MASTER PLAN: CONCEPT SUBMISSION ONE

EASTERN MARKET METRO PARK WASHINGTON, D.C. - EXISTING CONDITIONS ANALYSIS

PN 2018043 | 11.20.2018 | DEPARTMENT OF GENERAL SERVICES + DEPARTMENT OF PARKS AND RECREATION

EASTERN MARKET METRO PARK WASHINGTON, D.C. • MASTER PLAN: CONCEPT SUBMISSION ONE

ORIGINAL MASTER PLAN EVALUATION

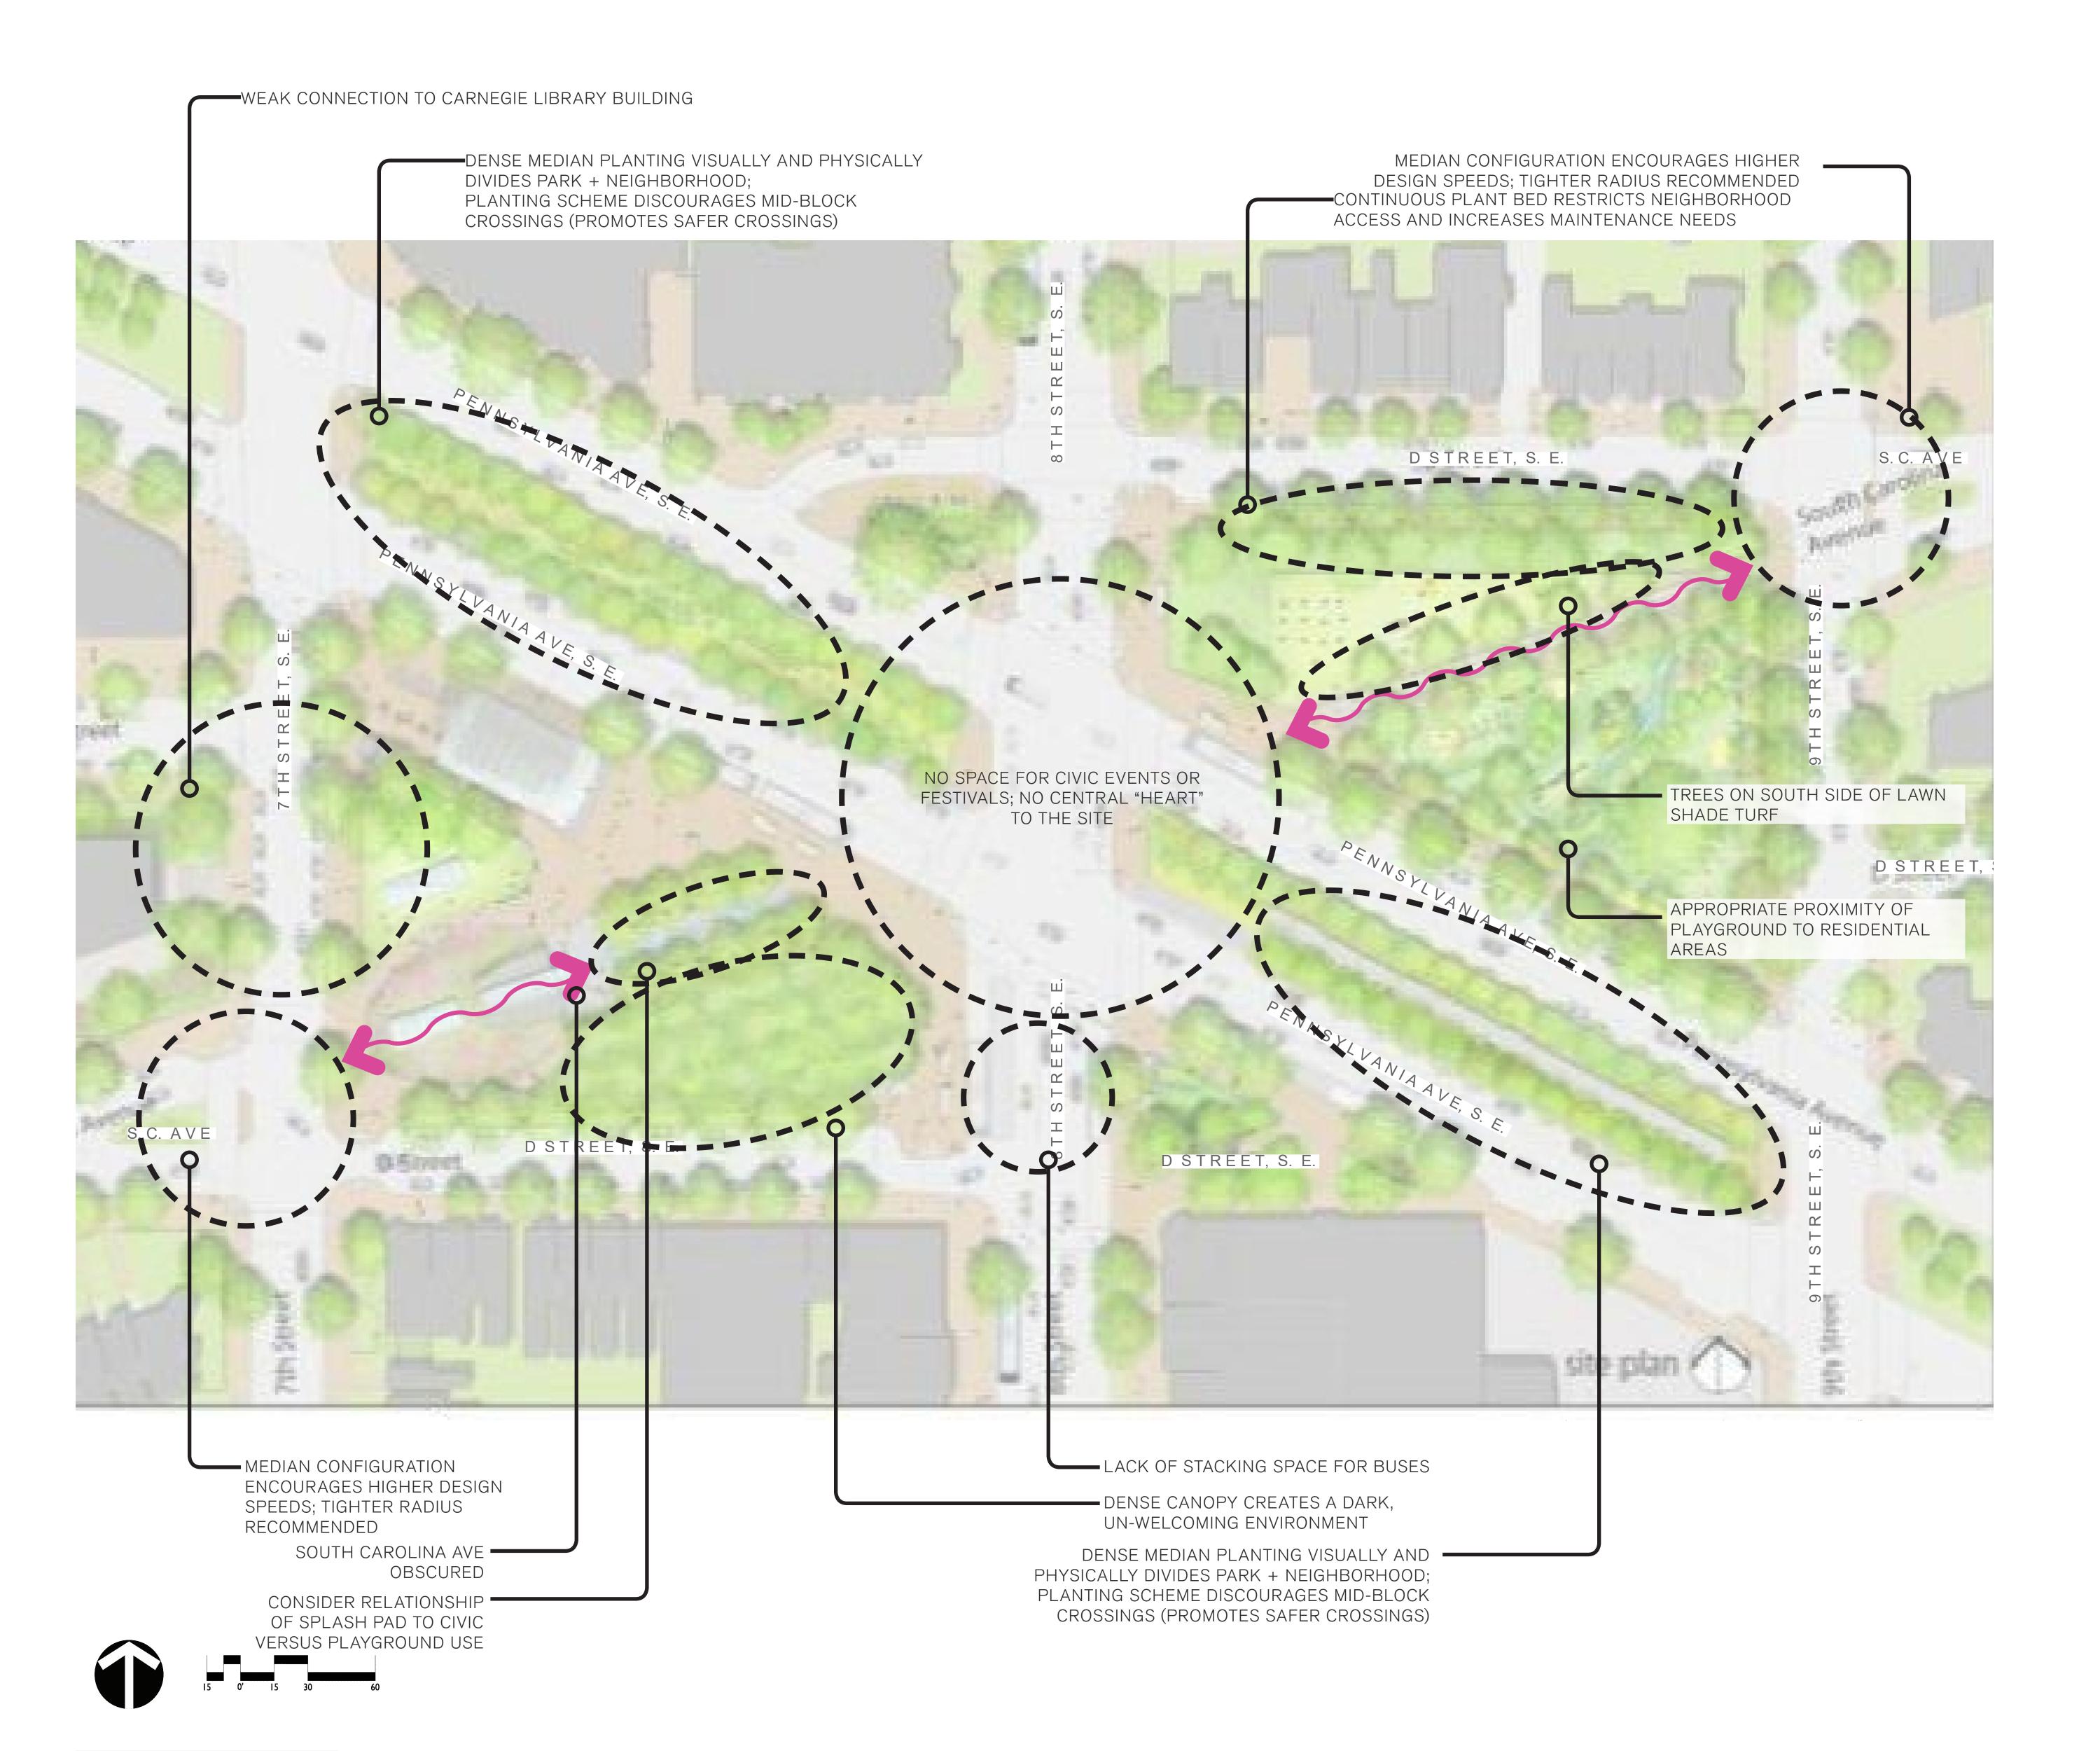
- Lack of civic use gathering space
- Recommendation: Include space for civic and neighborhood events
- Lack of community identity in majority of spaces
- Include opportunities for public art and interpretive features
- · South Carolina Avenue viewshed is blocked with library addition
- Recommendation: Maintain clear visual corridor • 8th Street to Metro cut-throughs partially interrupted
- Recommendation: Relocate water feature and maintain clear visual and physical corridor
- Splash pad location conflicts with primary circulation route
- Recommendation: Relocate water feature and maintain clear visual and physical corridor

- Stormwater management inlet conflicts with proposed curb alignments add significant cost impact
- Recommendation: Include space for civic and neighborhood events

- Splash pad location conflicts with DC Water Line
- Recommendation: Consider alternate locations and options for agreements with DC Water for locating within easement

- D Street closures and improvements require public space permit
- Recommendation: Carefully coordinate with DDOT for successful permit
- Potential maintenance risk in playground water pump feature

- Recommendation: Consider alternate feature for play and education
- Extensive grading required to make Pennsylvania medians bioretention adds significant cost impact; Bioretention conflicts with utilities and easements. Recommendation: Relocate bioretention

- Trees in Pennsylvania medians conflict with utilities and WMATA
- Recommendation: provide shrubs, perennials, and groundcovers only in median
- · South Carolina median additions increase speeds and potential accident risk

- Recommendation: Provide 90° intersection alignment
